### RESPONSE TO COMMENTS - TENTATIVE REVISED WASTE DISCHARGE REQUIREMENTS FOR SUNSHINE CANYON CITY/COUNTY LANDFILL, SYLMAR, CALIFORNIA (FILE NO. 58-76)

CALIFORNIA REGIONAL WATER QUALITY CONTROL BOARD LOS  
ANGELES REGIONREVISED WASTE DISCHARGE REQUIREMENT  
FOR  
BROWNING-FERRIS INDUSTRIES OF CALIFORNIA, INC.  
(SUNSHINE CANYON CITY/COUNTY LANDFILL)**Response to Comments**

TYPICAL CROSS-SECTION  
FINAL LANDFILL COVER  
AND REVEGETATION PLAN

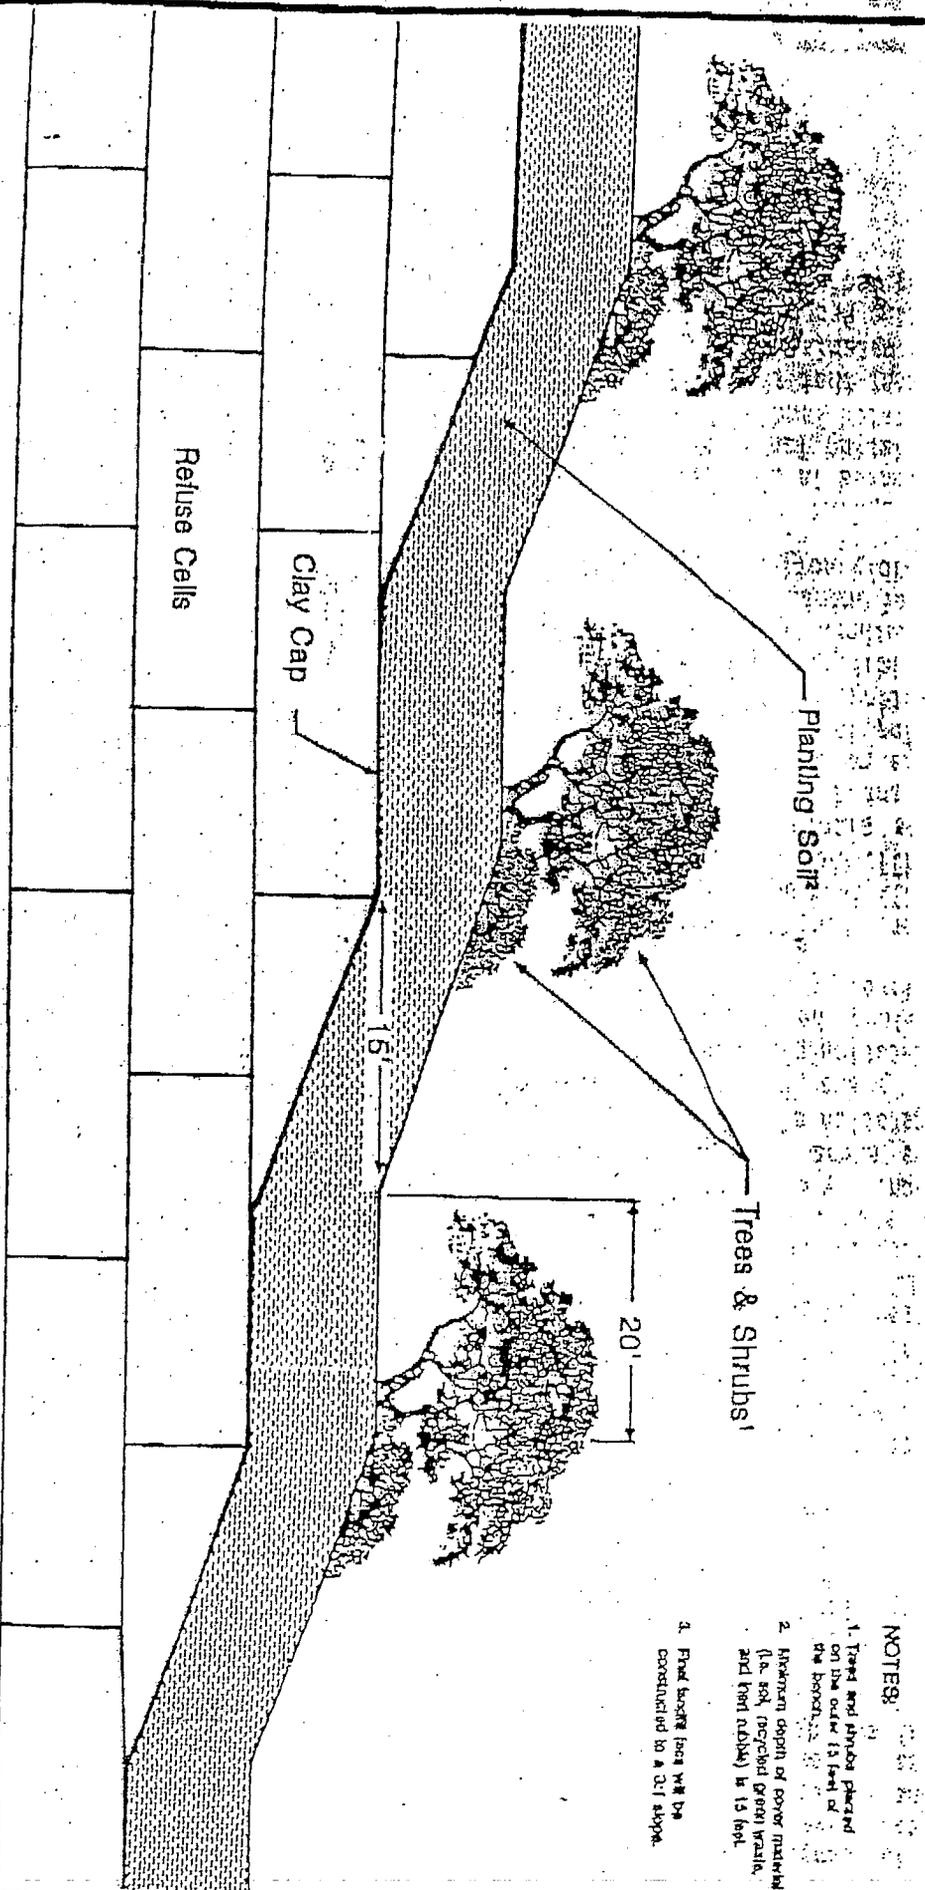
Comment: *Both the EIR and SEIR contain drawings of final covers with trees. To sustain what is described in the environmental documents as a "mosaic of trees and scrubs", there must be a final cover of soil much deeper than the 2 ft. proposed by the operator.*

From the very first approvals of Sunshine Canyon as a landfill the community was promised a final cover as described in both the EIR and the Subsequent SEIR. The attached diagram is a copy of the drawing that appears in those volumes. The wonton destruction of the closed canopy oak forest (at that time the densest in the County) was an environmental tragedy. To sustain what is described in the environmental documents as a "mosaic of trees and scrubs" there must be a final cover of soil much deeper than the 2 ft. requested by the operator. I know that it is much cheaper to throw wild grasses over the trash, but this is a clear betrayal of those who have waited 50 years for any portion of the landfill to be properly closed.

Response: State and Federal regulations require that landfill final cover must be designed to minimize infiltration and erosion. The final cover system that BFI proposed in the JTD meets the requirements included in Section 21090 of 27 CCR for Class III landfill final cover systems. The Regional Board may approve alternative final cover systems, such as the five-foot thick monolithic final cover that has been constructed on top of the closed City Landfill Unit 1. However, large trees, such as oak, are not suitable to be planted on the final cover because, with their deep root system, they may damage the integrity of the final cover and cause maintenance problems.

SUNSHINE CANYON LANDFILL  
 FINAL COVER SECTION

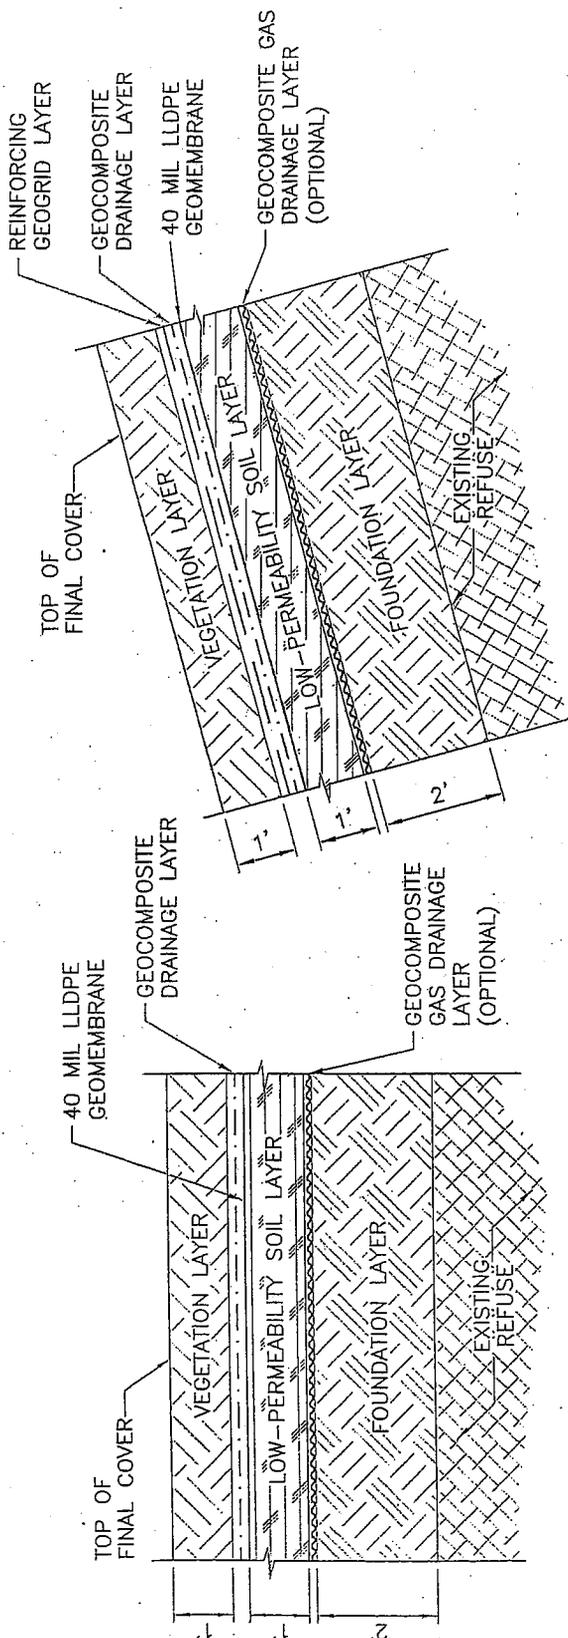
Comment: Replace Figure 5 of the tentative WDRs and Figure T-2 of the tentative Monitoring and Reporting Program with updated figures.

In addition, Figure 5 referenced in this paragraph should be replaced with the Final Cover Section figure attached herewith, which is from the Joint Technical Document (JTD).

Response: Those two figures have been replaced with new figures provided by BFI.

**A-MEHR, INC.**  
 220105 SAN FERNANDO CANYON LANDFILL  
 (949) 208-0187 (949) 208-8107 FAX  
 Sunnyside Canyon City Landfill  
 Enclosure Area  
 Ectis Plan  
 Aerial Topography dated as 01/22/08

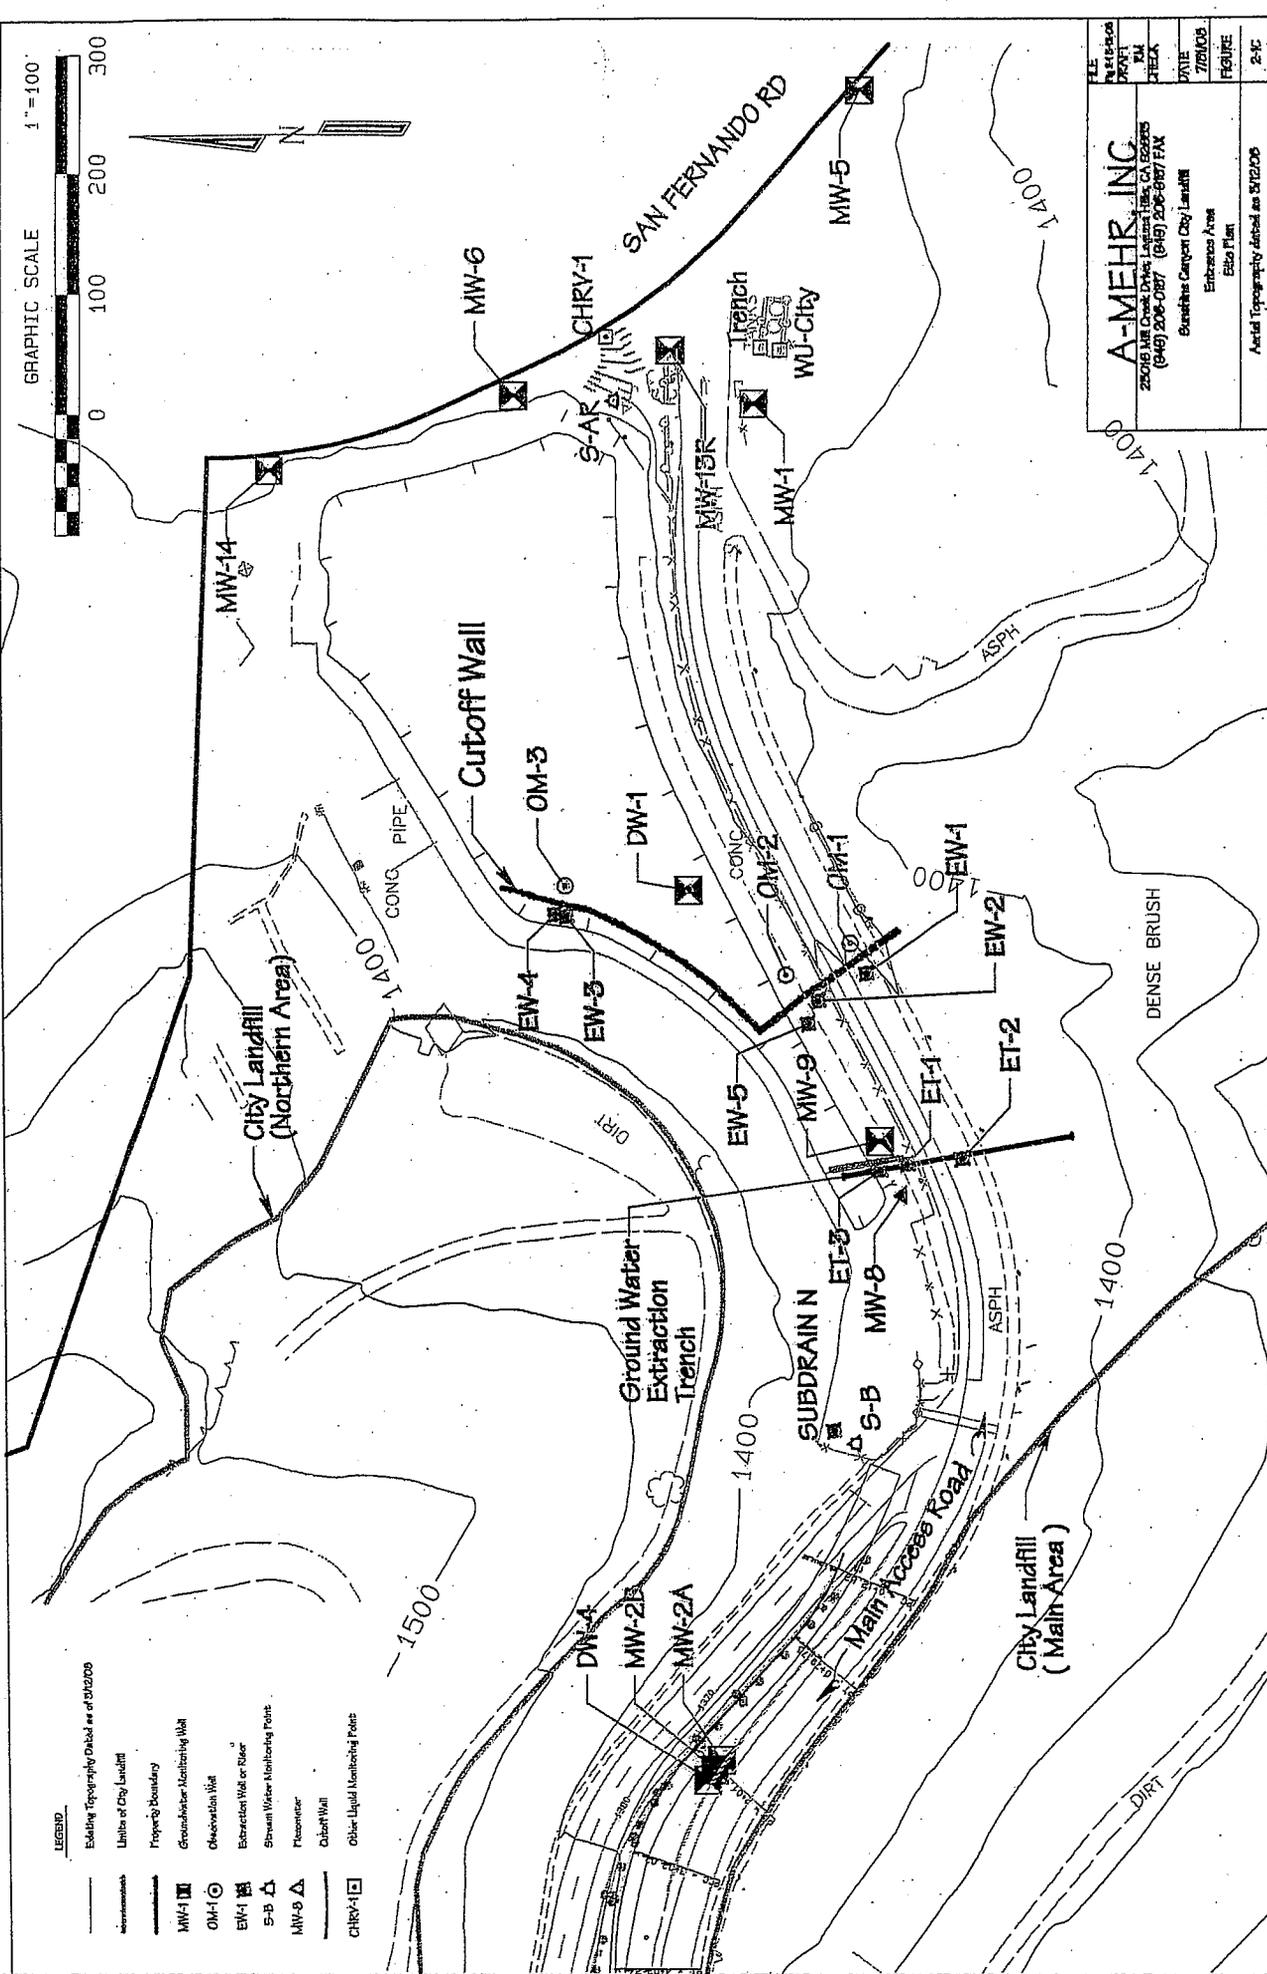
We question as to whether or not there are sufficient wells at the landfill entrance to detect "any and all" migration off-site of contaminants. Figure T-2 of the Monitoring And Reporting Program shows MW-1, MW-5 MW-13R, MW-6 & MW-14. However, MW-6 & MW-14 are upgradient leaving only MW-1, MW-5 MW-13R downgradient. MW-1 and MW-13R are 100 feet apart and MW-1 and MW-5 are closer to 300-feet apart, which leaves far too great a distance between them to adequately detect any and all contaminants leaving the site. The Metropolitan Water District of Southern California owns the Balboa Inlet Tunnel, which conveys untreated municipal water to the Jensen Filtration Plant. The 14-foot tunnel comes within about 500 feet of the eastern boundary of the existing landfill situated at the mouth of Sunshine Canyon. The top of the tunnel, at its shallowest point, lies approximately 25 feet below the surface. Depth to groundwater at the same location is on the order of 10 feet or less. Dependant upon flow rates, the hydraulic pressure head in the tunnel is approximately 3 to 19 feet lower than the ground water level. Under these conditions, ground water may seep into the tunnel. We believe that the prudent course of action would be to add additional wells at the mouth of the canyon

Page T-17, Figure T-2 – Figure T-2 should be updated to include extraction riser ET-3. An updated version of A-Mehr, Inc.’s site plan showing the location of ET-3 is attached.

Response: Based on Regional Board staff's understanding of the groundwater flow patterns at the site, we believe that the six groundwater monitoring wells (MW-1, MW-5, MW-6, MW-13R, MW-14, and DW-1) located down-gradient to the cut-off wall in the mouth of Sunshine Canyon are sufficient to detect any pollution of groundwater that flows out of the Canyon. The three observation wells (OM-1, OM-2, and OM-3) near the cut-off wall that have been used to observe groundwater levels may also be used for groundwater quality monitoring if needed. As mentioned
